PERMIT

SEWAGE DISPOSAL SYSTEM

SUBDIVISION Woodmark ROAD Pointer Hill Court LOT _____

PROPERTY OWNER Charles Lancellotta

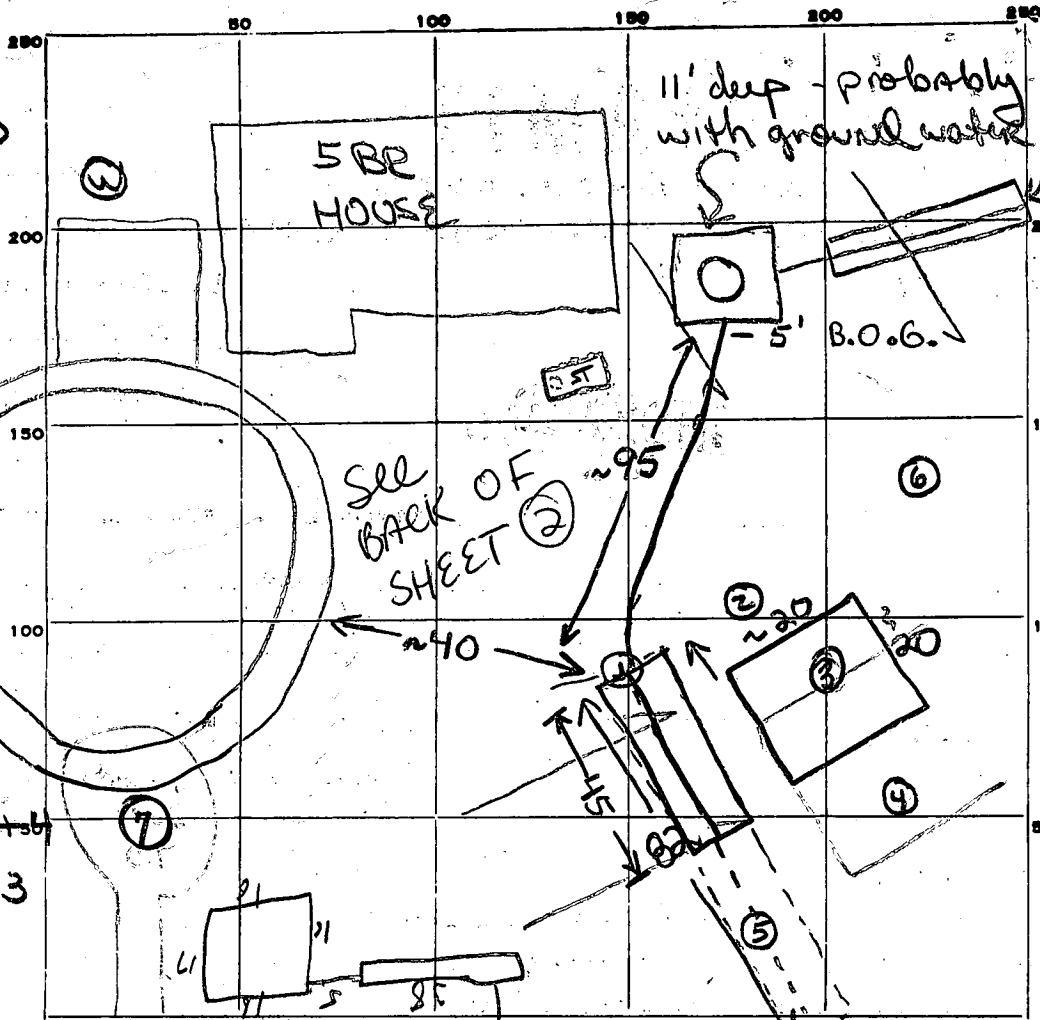
11' deep - probably in contact with ground water

SPRINGHEADS throughout lot

Holes ① → ⑥

with 15 to 30' of one another - (opened ON ARRIVAL 4/30)

variable clay layer WATER AS INDICATED

- 1 - 9' - DRY
- 2 - 9 1/2' - WATER
- 3 - 8' - WATER
- 4 - 7 1/2' - WATER
- 5 - 9' - WATER
- 6 - 4 1/2' - DRY

REMARKS 30 Apr 79 - SHALLOW TRENCH - 80' long, 5' wide, 5' deep with 3' of stone. Directed as indicated with the contour. Gave OK to gravel portion of trench. (GLK) 1 MAY 79 - Contacted by Mr. Ohler - phone during excavation spring head was hit at point (P). Instructed Ohler to backfill last 40' over spring head 3 to make up footage in backing had provided soil is suitable. (GLK) 1 MAY 79 see sheet 2

LANCELLOTA - POINTER HILL CT

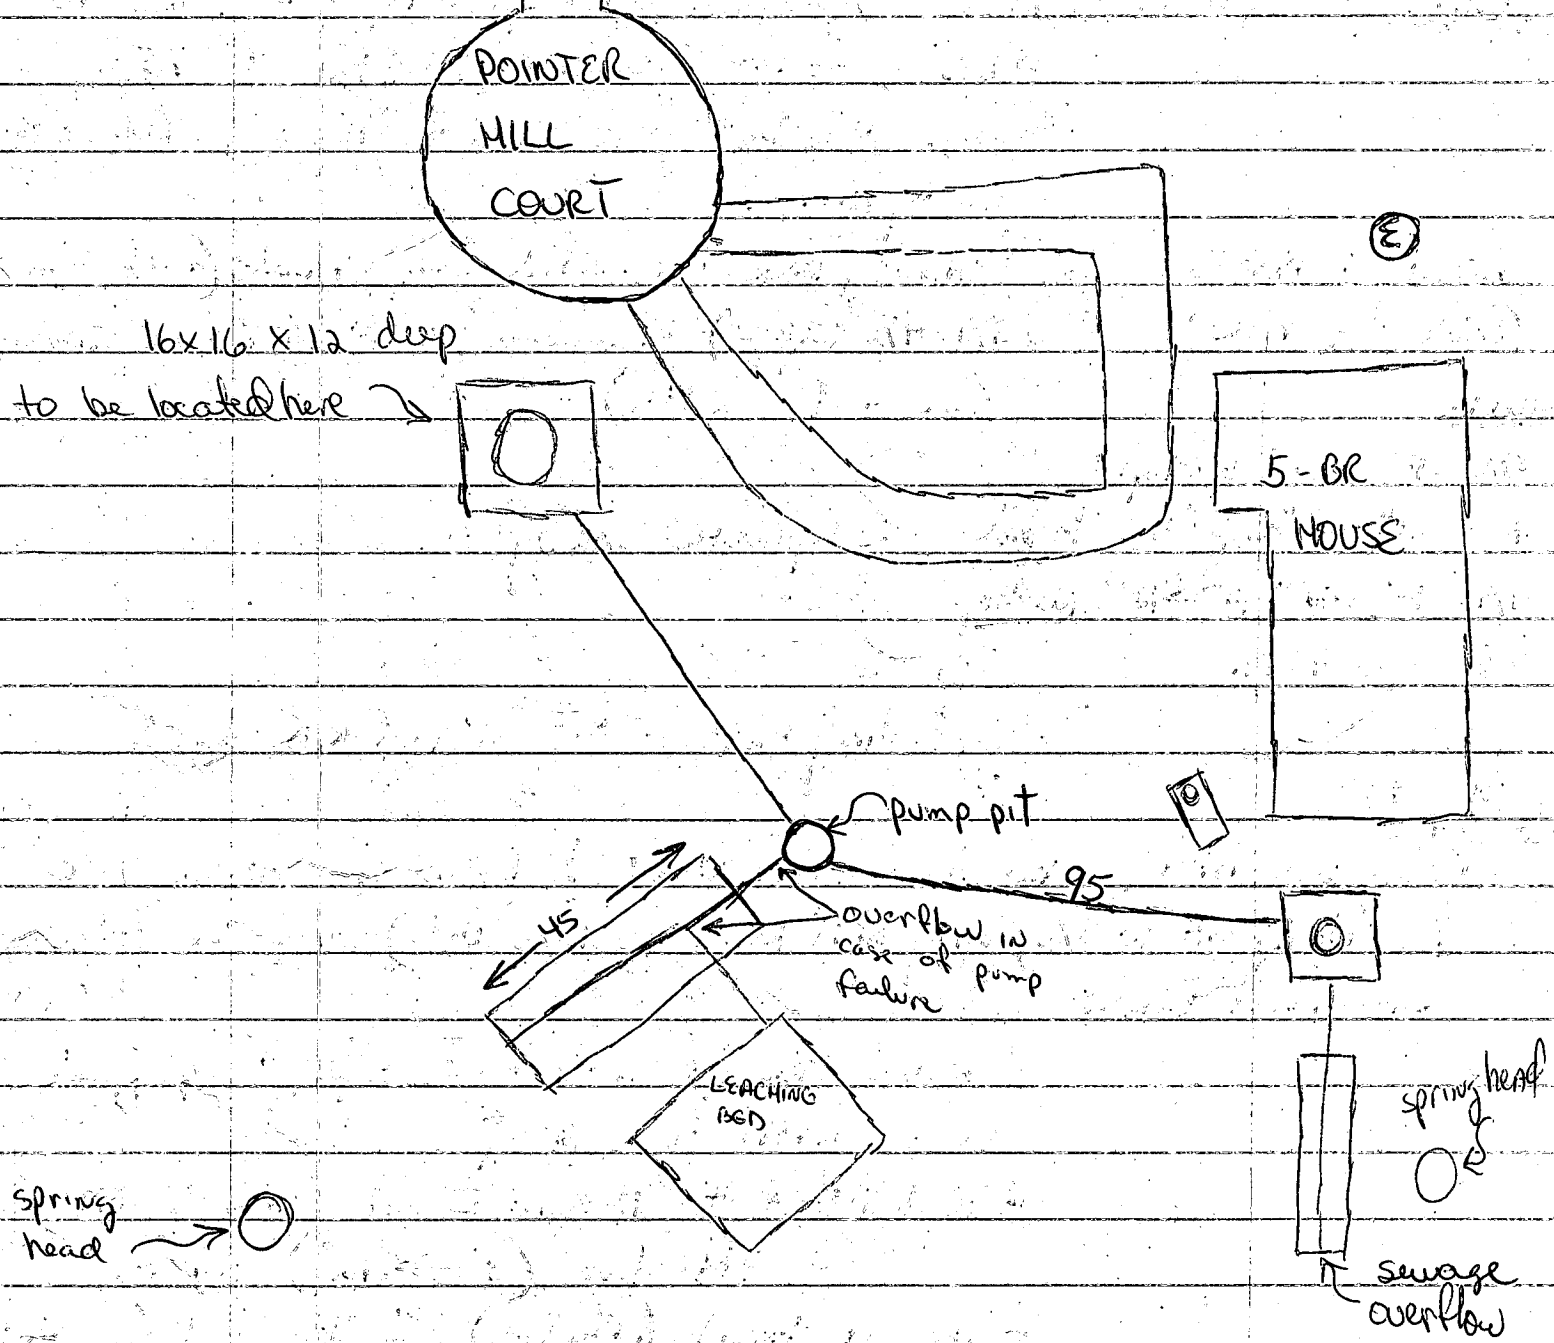
1 MAY 79 - Site Visit - Trench excavated with portion backfilled to have a total usable length of 45' sidewall & bottom area of trench predominantly sandy loam.

Vicinity of hole ③
(center of bed)

Leaching bed excavated on arrival (~20x20x 3 1/2 - 4 1/2' deep) however, soil looks questionable.
(see test results)

3 1/2' 12¹³ → 12²¹ No drop

4' 12²¹ → 3/4" drop - then stopped

4 1/2' 12²⁰ → 12⁴⁰ 12⁴⁰ → 12⁵⁵ No drop

7 1/2' - WATER

} plastic sandy clay

Failing tests - STOP WORK (GLK)

⑦ (clayey silt to 3 1/2', silty sand loam to 12 1/2' DRY) made the following recommendations:

- installation of watertight pump pit equipped with dual pumps
- installation of 16 x 16 □ drywell with 9' effective (3' → 12') depth.
- use of trench (effective) & leaching bed (noneffective) as overflows in case of pump failure

Location as on back of this sheet. (GLK)

Gave OK to backfill sewer from old dry well to pump pit & to call for final when all work is complete.
